LUFTHAVSVERKET  
LUFTHAVSVEIEN 11, 1330 OSLO LUFTHAVN  
LUFTDYKTIGHETSPÅBUD  
(LDP)

Seilfly  
Rolladen Schneider-lb  
Erstatter Rolladen-  
Schneider-la

Air brake locking bracket on landing gear box (Crack region marked)

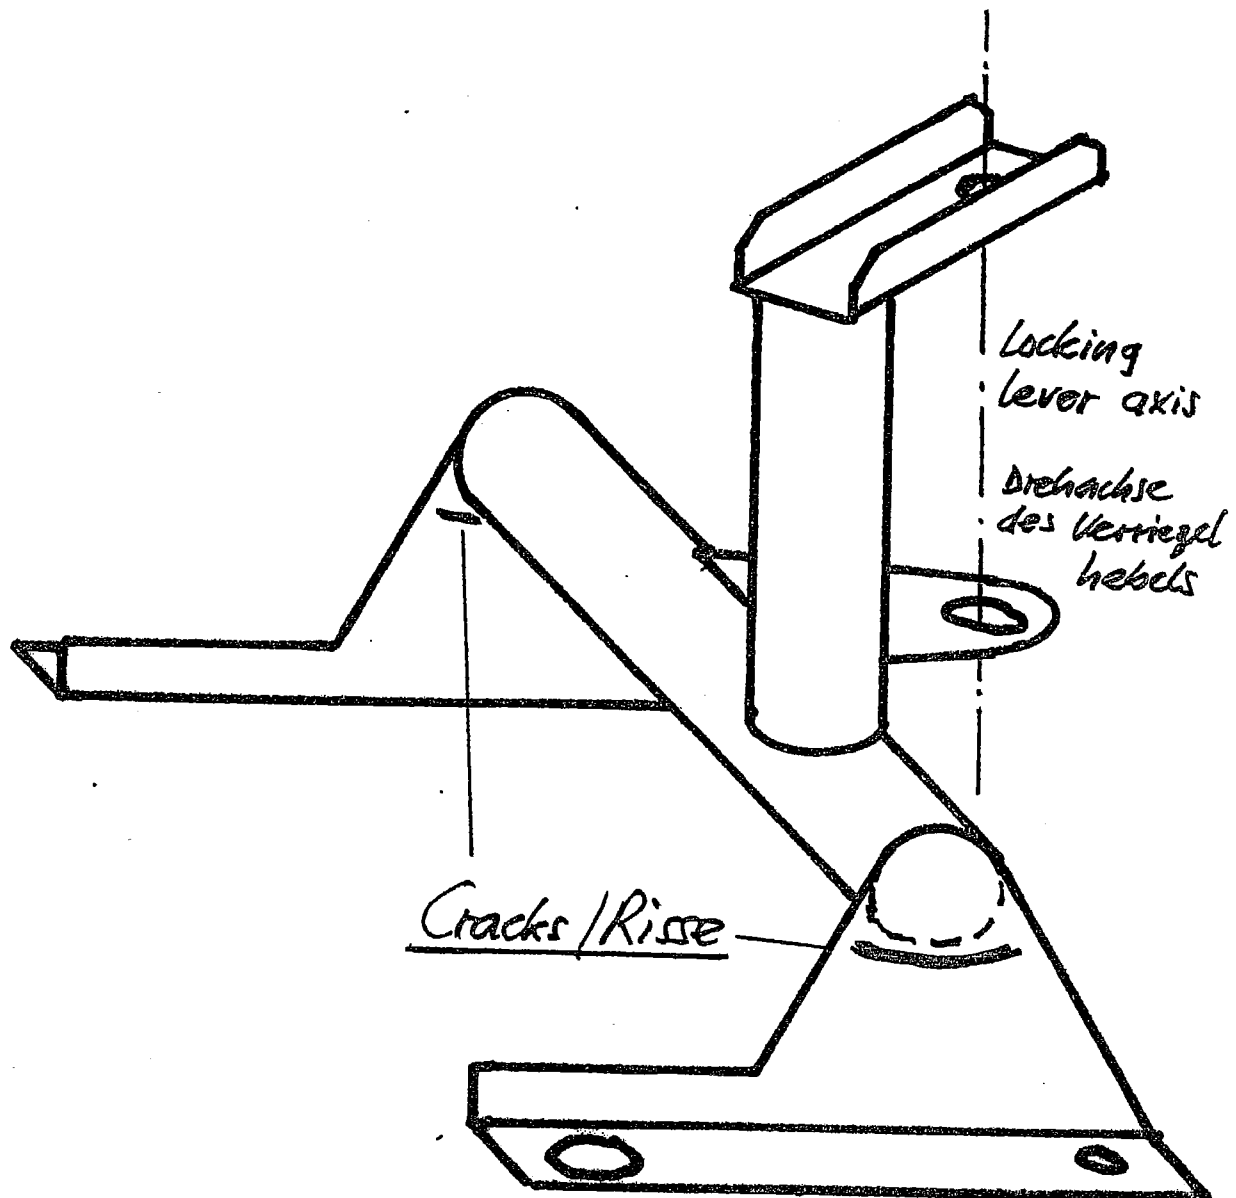
- Material and Instructions:
1. With sailplane rigged, check air brake locking bracket on rear landing gear box for lateral movement during air brake locking.
  2. Check both fixing angles at this air brake locking bracket for lateral deformation (indication by cracks in paint or paint chipping off) and/or cracks in the welding region to the tube. (See sketch on page 2)
  3. Only with cracks or deformation existent, disassemble the bracket. Repair and modification required according to drawing 3R6-27b .
